**17 March 2022**

## **Central Sydney Planning Committee**

- 1. Disclosures of Interest**
- 2. Confirmation of Minutes**
- 3. Matters Arising from the Minutes**
- 4. Election of Deputy Chairperson**
- 5. Development Application: 37-49 Pitt Street, 49A-57 Pitt Street, 6-8 Underwood Street, 6 Dalley Street and 8-14 Dalley Street, Sydney - D/2021/665**
- 6. Approved Variations to Development Standards Reported to the Department of Planning, Industry and Environment**
- 7. Summary of Applications to be Reported to the Central Sydney Planning Committee**

**Figure 46:** Proposed building tower height, podium height, setbacks and through site link dimensions

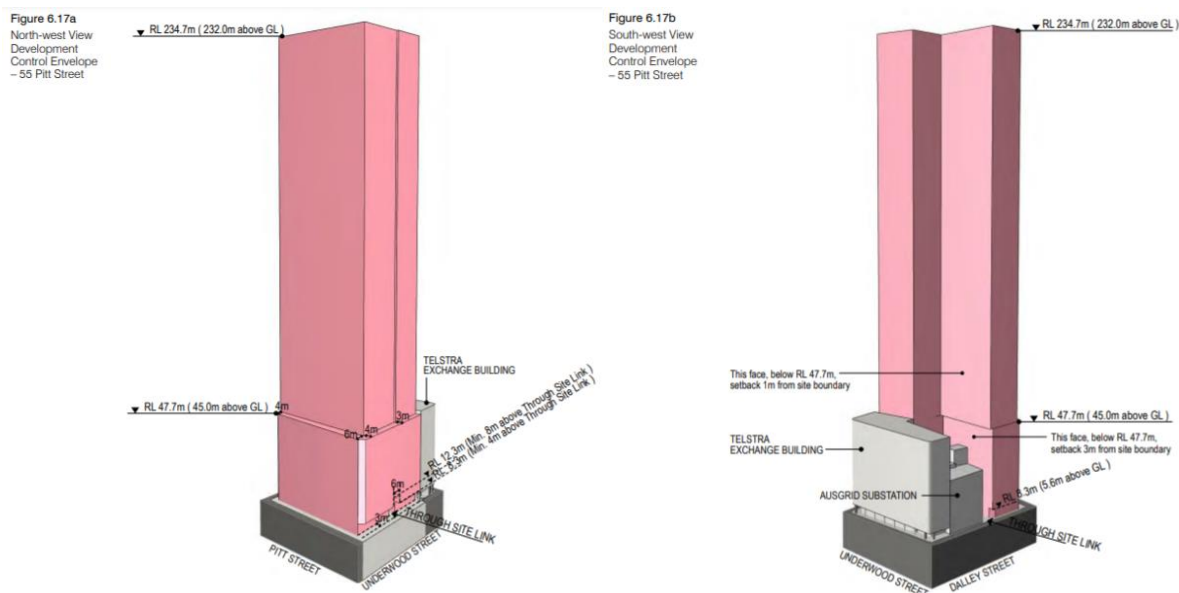
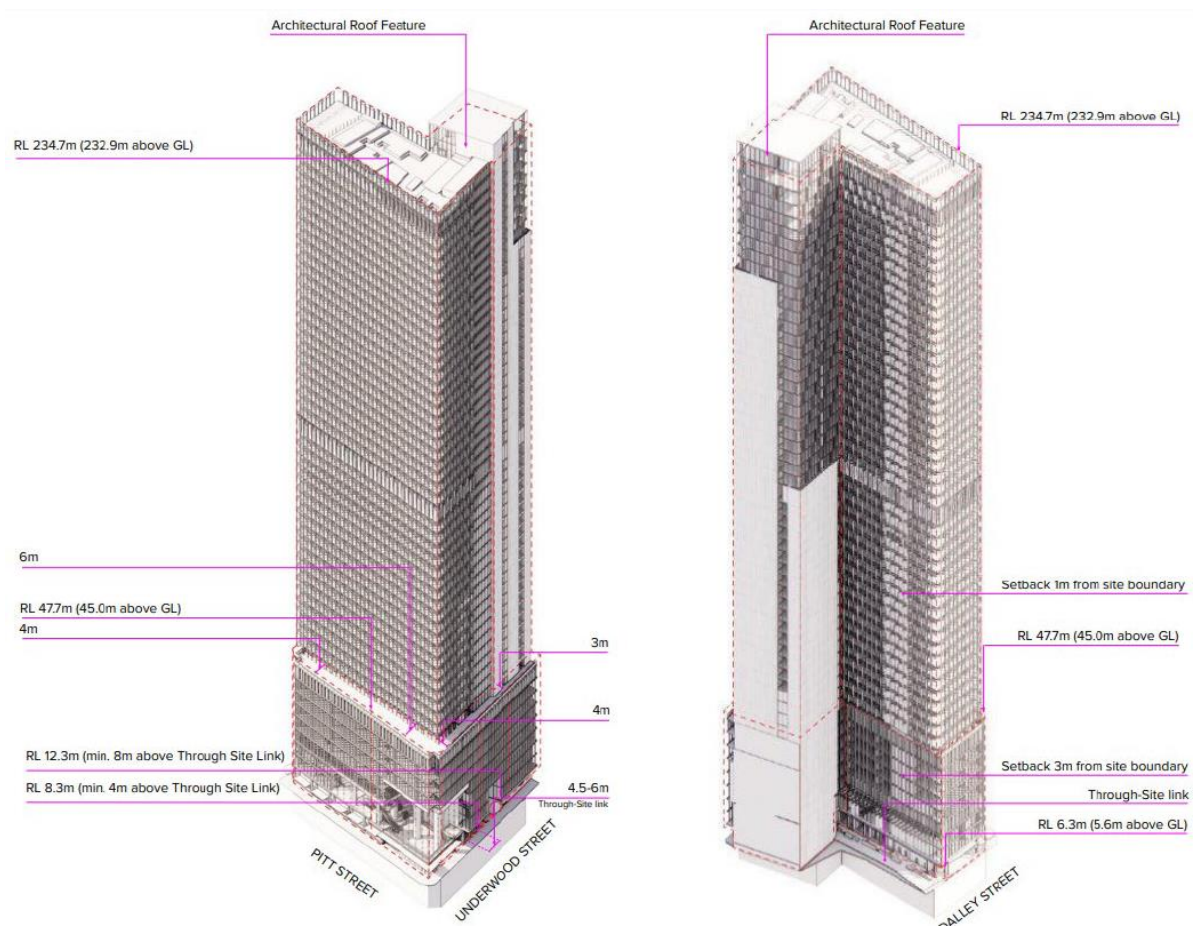
77. Although the proposed development is generally consistent with the majority of the numeric controls prescribed for the site, some aspects of the development do not comply with the DCP and are discussed in further detail below.

**Figure 47:** Perspective drawing of Queens Court from Dalley Street. Ramped vehicle access must be provided to service the Ausgrid site to the left of the image.

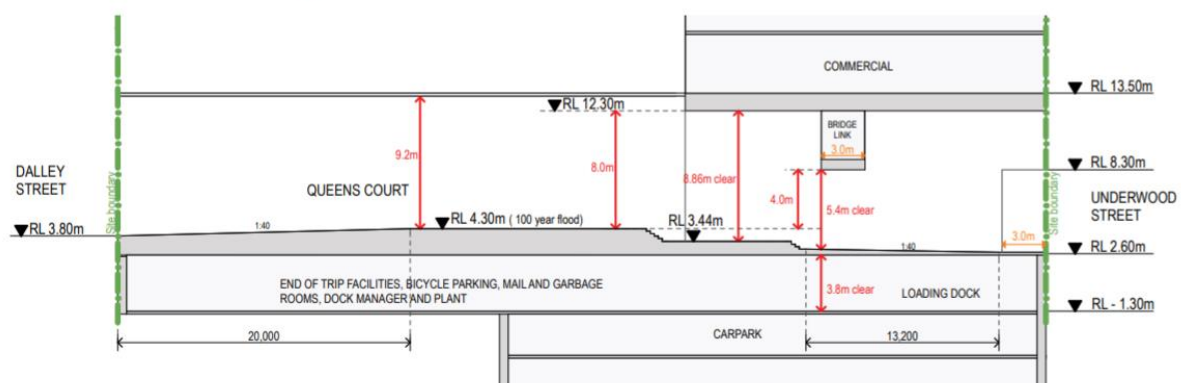
80. The design of Queens Court provides ramp access to part of the laneway whilst the remaining part is access from Dalley Street via stairs to address flood levels as shown in Figure 47 below. The use of the portion of Queens Court by vehicles servicing the Ausgrid substation building and the Ausgrid chamber below needs to be clarified as this will potentially require a clearance to the existing Queens Court road reserve.

81. It is recommended that this ramped area be maximised in width and may require a slight relocation of planters to be located wholly within the privately owned portion of the through-site link. A condition is recommended requiring the submission of detailed plans of Queens Court showing widths to allow for vehicle access and for all public domain elements to be located within privately owned land to ensure that all the publicly accessible spaces surrounding the site correlate and work successfully.

**Figure 50:** Overshadowing caused by proposed development at 9am and 12pm on winter solstice identified in red. Subject tower site outlined in green. Residential uses identified in blue.

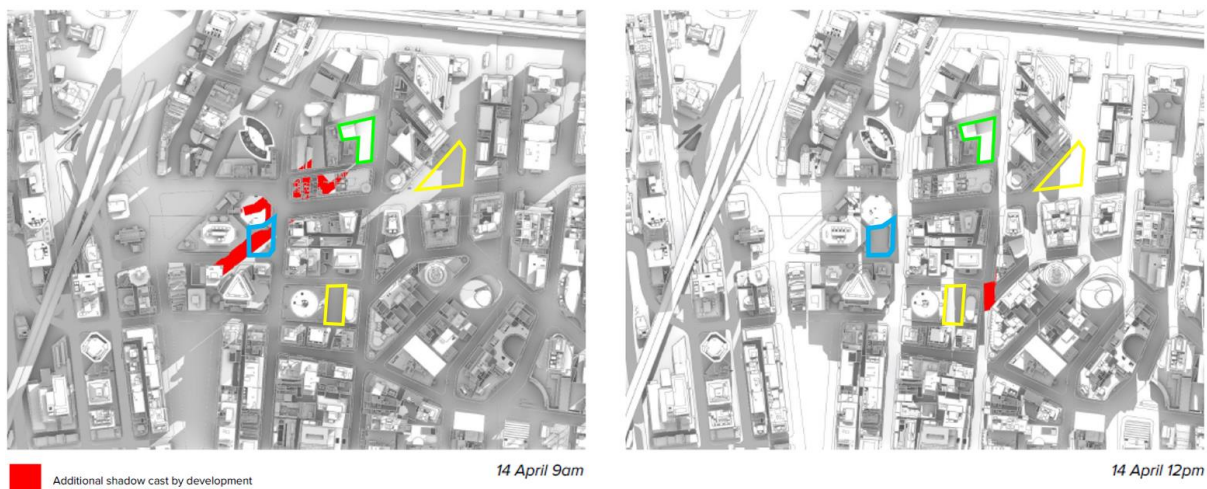
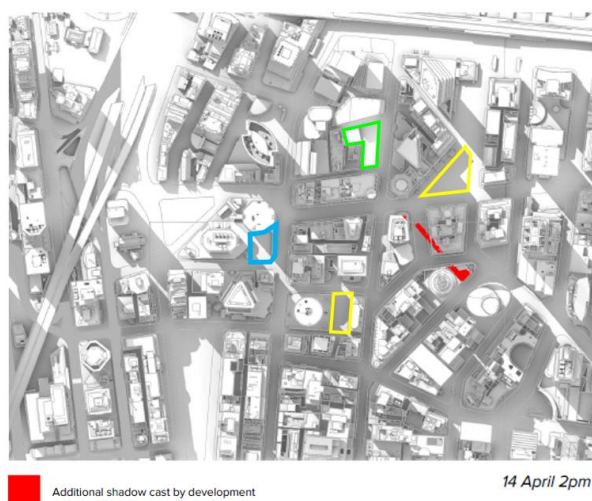
87. Clause 6.18 of the Sydney LEP 2012 and Sections 4.2.3.1 and 5.1.7.2 of the Sydney DCP 2012 require developments to address solar access to surrounding uses and within Central Sydney, to protected public places.
88. Although uses surrounding the site are predominantly commercial and tourist and visitor accommodation, residential apartment uses are noted at 4 Bridge Street, 44 Bridge Street, 8 Loftus Street, 18 Loftus Street and 15 young Street. Submitted shadow diagrams, as provided in Figures 50 and 51 below, confirm that the proposed development will have no additional overshadowing impact on surrounding residential uses.

89. When considering the overshadowing impact of the proposed development to public places, the greatest impact occurs at 9am on 14 April (see figures 52 and 53 below) where the shadows fall upon the forecourt of 243-259 George Street. Although the forecourt to this site is publicly accessible, it is not a protected public place as identified in Clause 6.18 of the Sydney LEP 2012 and Section 5.1.7.2 of the Sydney DCP 2012.
90. The proposed tower will not result in any additional overshadowing to protected public places, specifically Macquarie Place to the east and Australia Square Plaza to the south. Figures 52 and 53 provide shadow diagrams of the proposed tower on 14 April and surrounding protected public places that must not be impacted by additional overshadowing as required in the Sydney DCP 2012.

**Figure 58:** Perspective drawing of proposed architectural roof feature form exceeding the maximum height limit

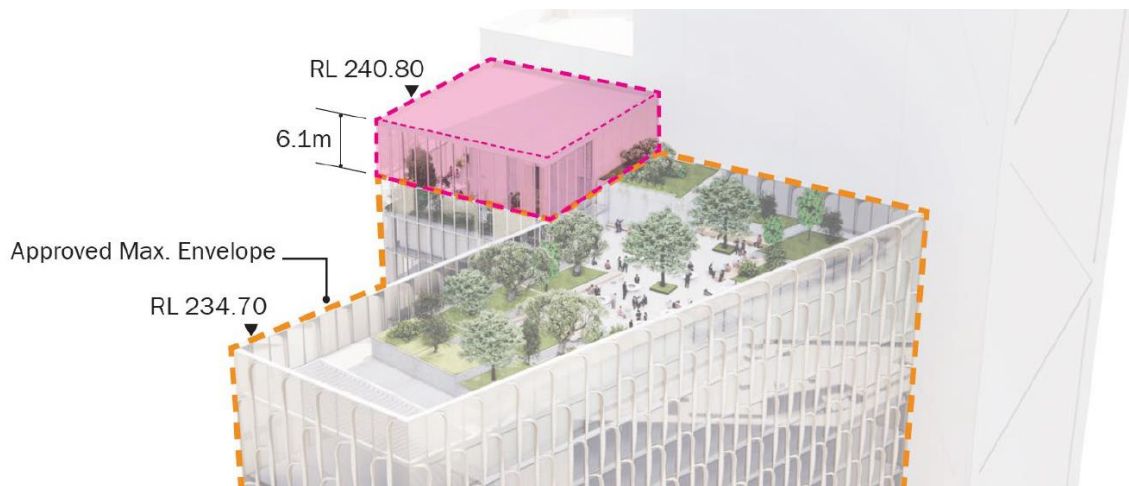
96. Clause 5.6 of the Sydney LEP 2012 allows architectural roof features to exceed height limits provided the feature does not cause an adverse visual impact and is integrated with the building design. Figures 57 and 58 below provide photomontage and perspectives drawings of the proposed architectural roof feature and the relationship of the feature with the main tower structure and maximum height limits.

97. Clause 5.6(3) requires the consent authority to be satisfied that the architectural roof feature:
- (a) is a decorative element on the uppermost portion of the building
